Kensington Gold Project

Final
Supplemental Environmental Impact Statement

Volume 2: Appendices A–L

Figure 1.2 Existing Productivity Zones in the TSF

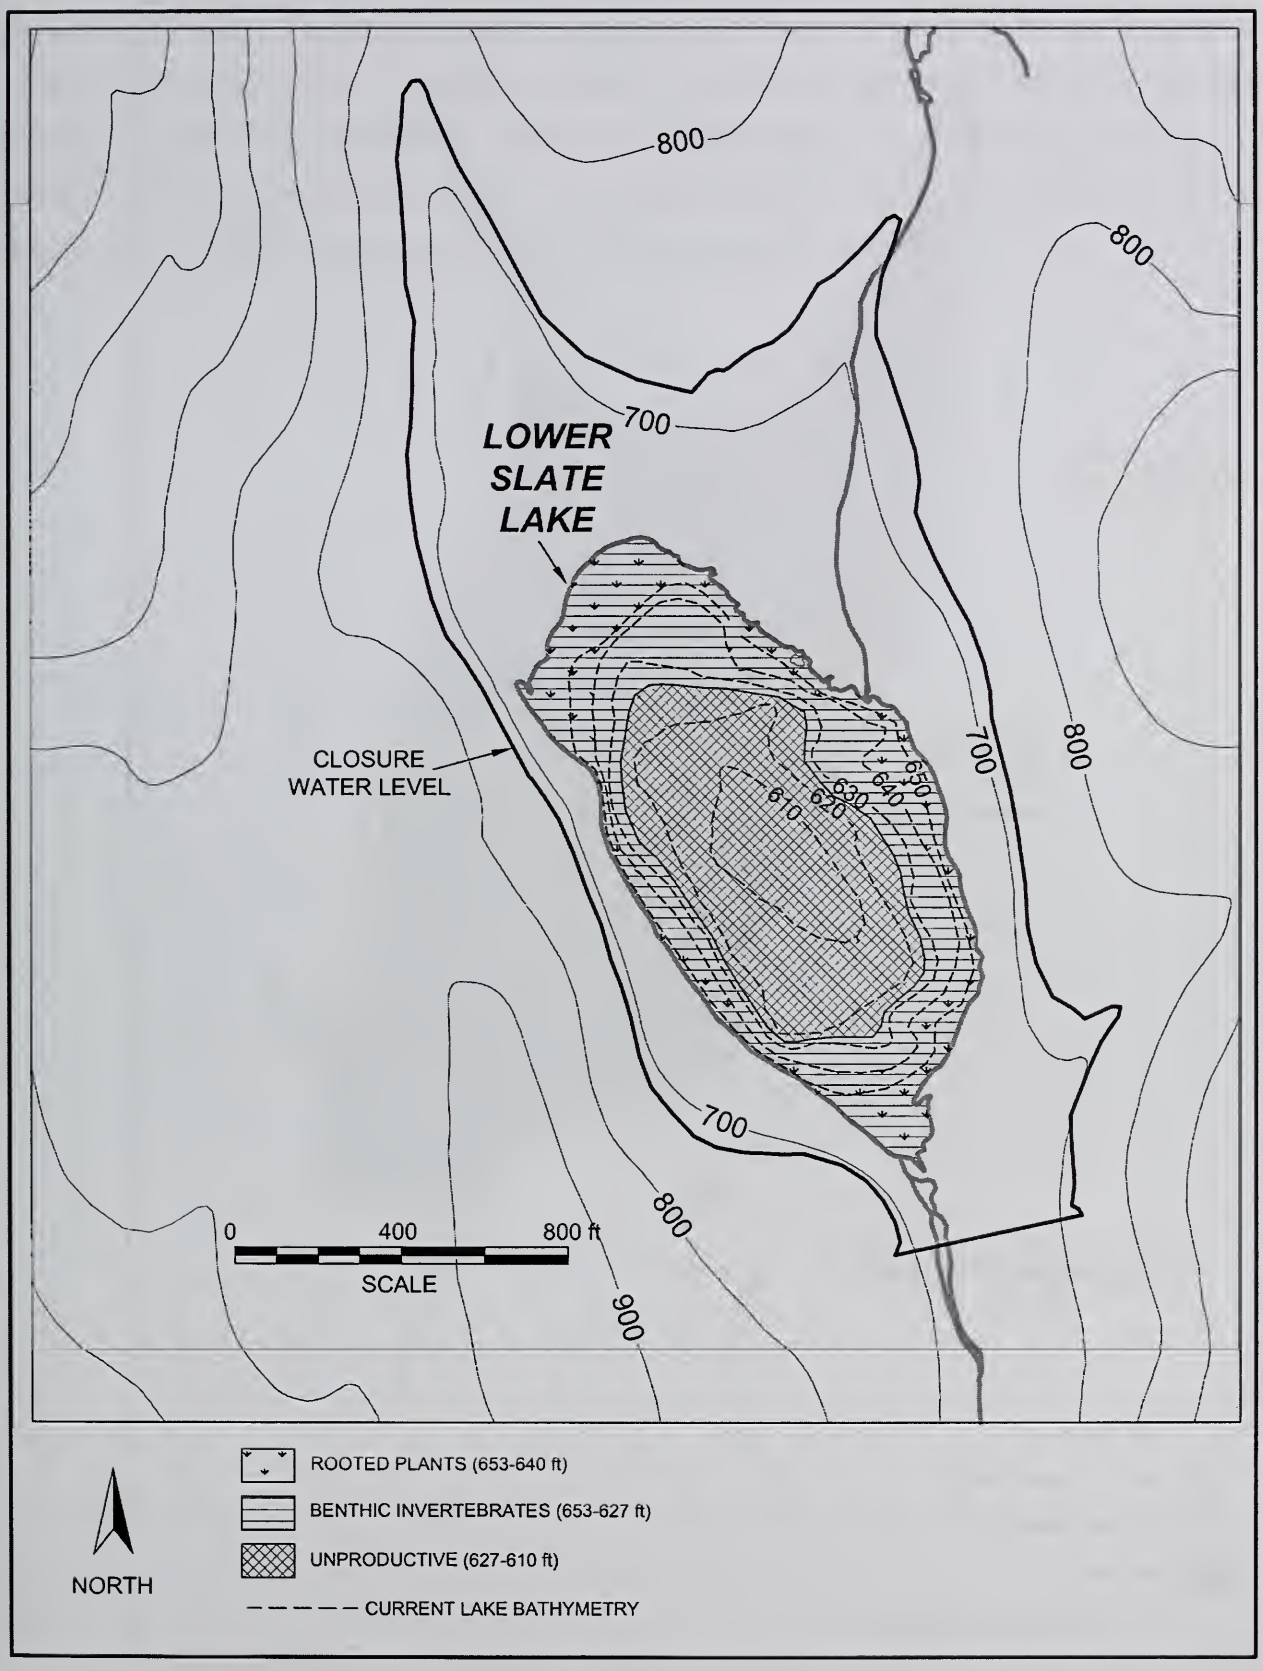
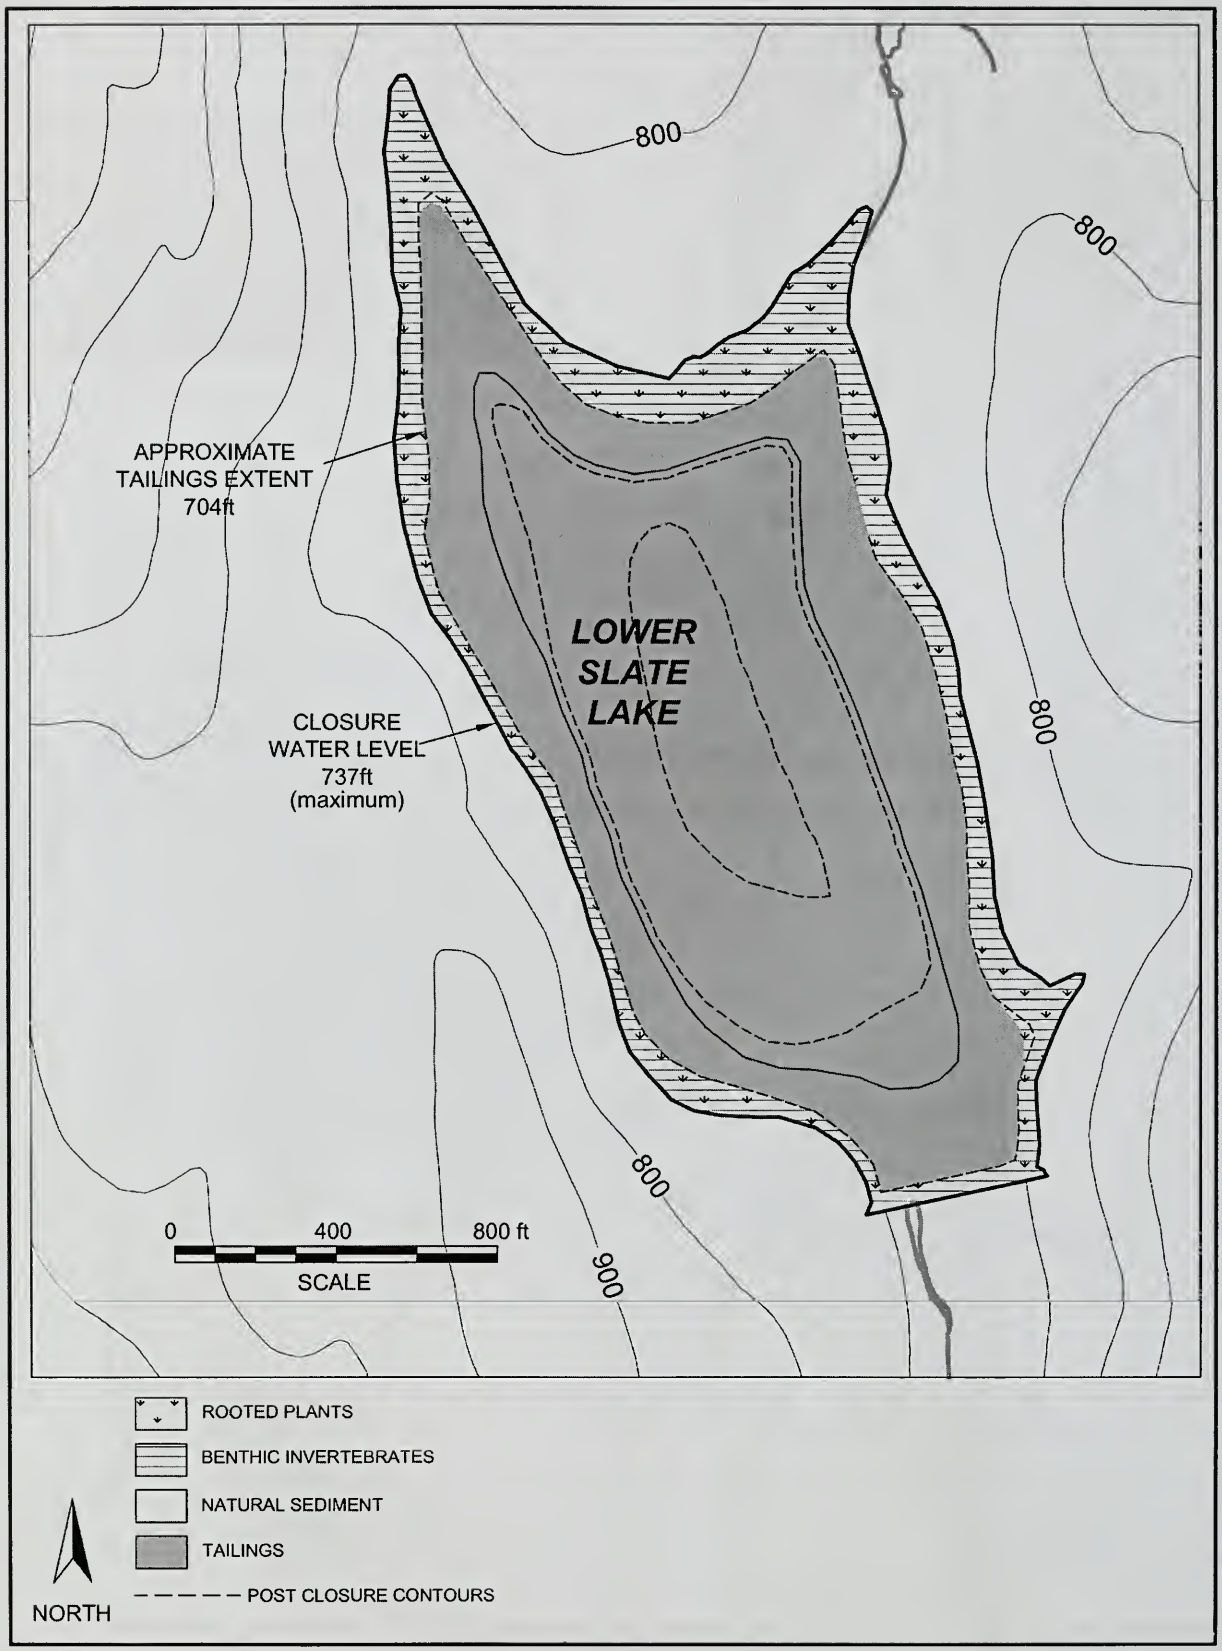
A-30		Last paragraph, 7th sentence: "digestion used in digestion used in..."
A-49		Why is the text at the top of the page italicized?
A-60		Sulfate/TDS: The previous permit uses 250 and 1000 as the average and the max.
C-4&5	Figures 1.2 & 1.3	The dotted portions in the key for Fig. 1.2 do not give any information. Shouldn't the plants, inverts and fish zone be different from the inverts and fish zone? Most importantly, Figs 1.2 and 1.3 are still difficult to compare to one another given their different labeling, orientation, etc. Please add a new figure just like Figure 1.3 but note the BEFORE project zones. Include depth definition in parentheses in the key to the figure, i.e., "rooted plants (<13 feet deep)". Figure 1.2 needs a quantification on descriptors such as productivity, unless this figure is meant to indicate the final desired condition of the lake. Please also include photos of the lake margins and vicinity.

Figure 5.1 Responses of Test Organisms to Kensington Tailings Relative to Concurrently Tested Natural Sediment.

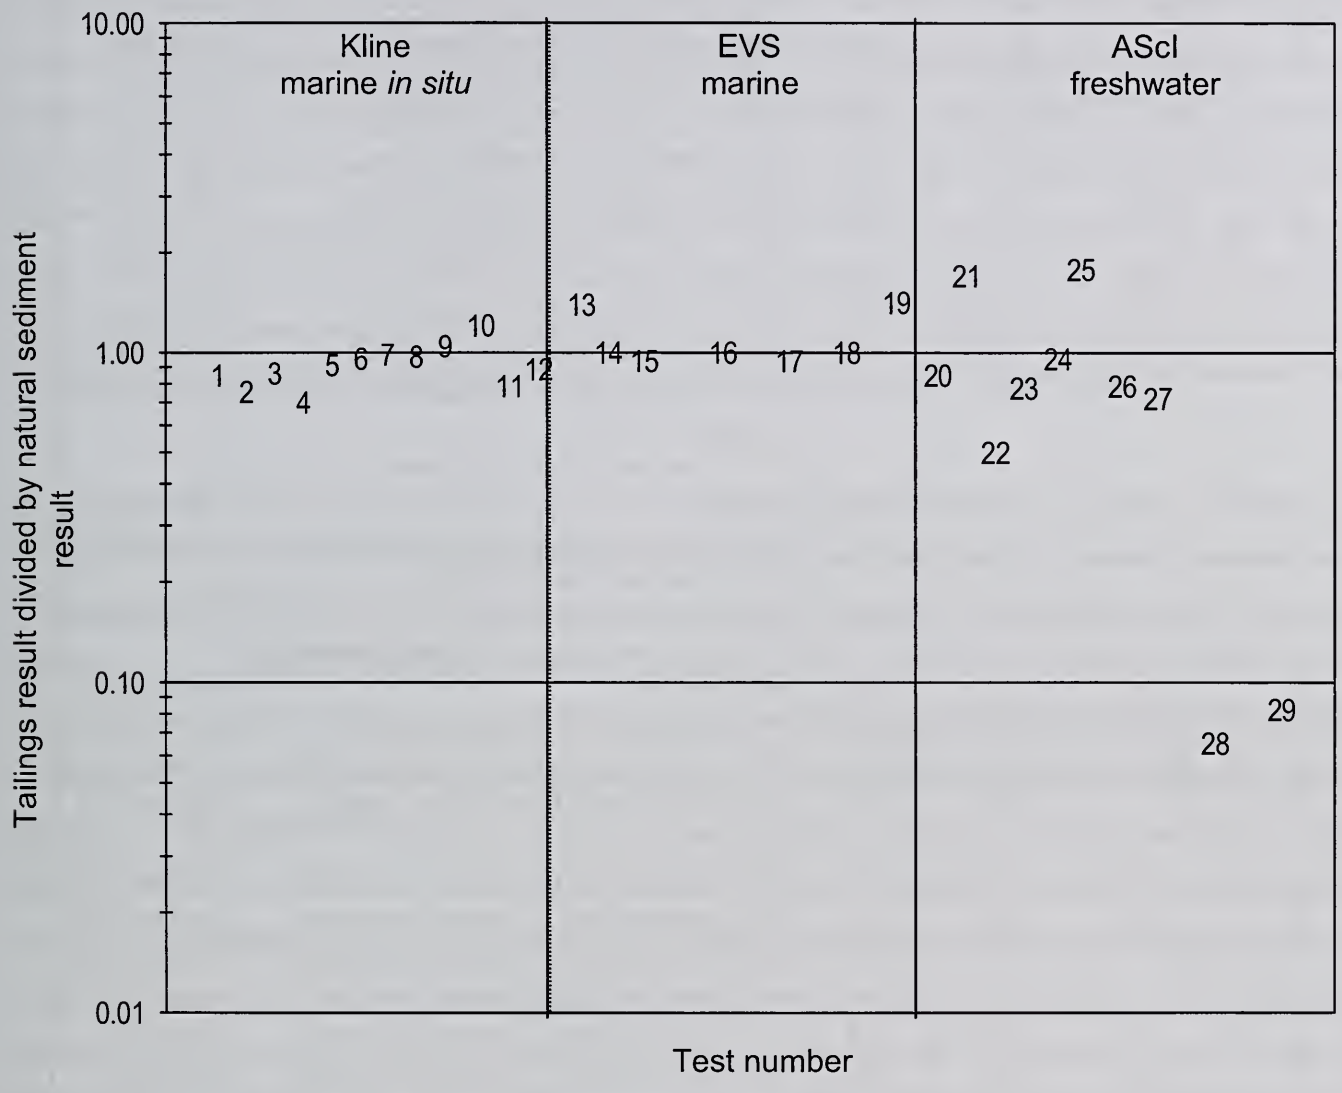
The discussion of the habitability of the tailings in section 5.2 needs improvement. Figure 5.1, for example, makes it appear that all endpoints are equal and with approximately half above and half below the "1" line, it is confusing to the reader. A summary table of the tests run and brief results would be useful. However, it must be stressed that not all endpoints are "equal". For example, #18 and 19 which refer to survival during bioaccumulation testing are not as important a finding as the amphipod bioassays. Macoma and Nereis are specifically selected as bioaccumulation test species because they are hardy and not expected to die during a 28 day exposure. See detailed comments on Appendix C below.

Friends of Berners Bay	JH3-22	The data needed to make comparisons between tailings and native substrate are provided in Table 5.4. As listed in this table, some of the results in the tailings are lower (poorer) than those in marine sediments, while some are essentially the same or higher (better) than those in the native marine sediments. The overall comparison of the different studies is provided in Figure 5.1, which shows that most of the marine tests resulted in comparable results in tailings and sediment. Additional text has been included to clarify these comparisons.
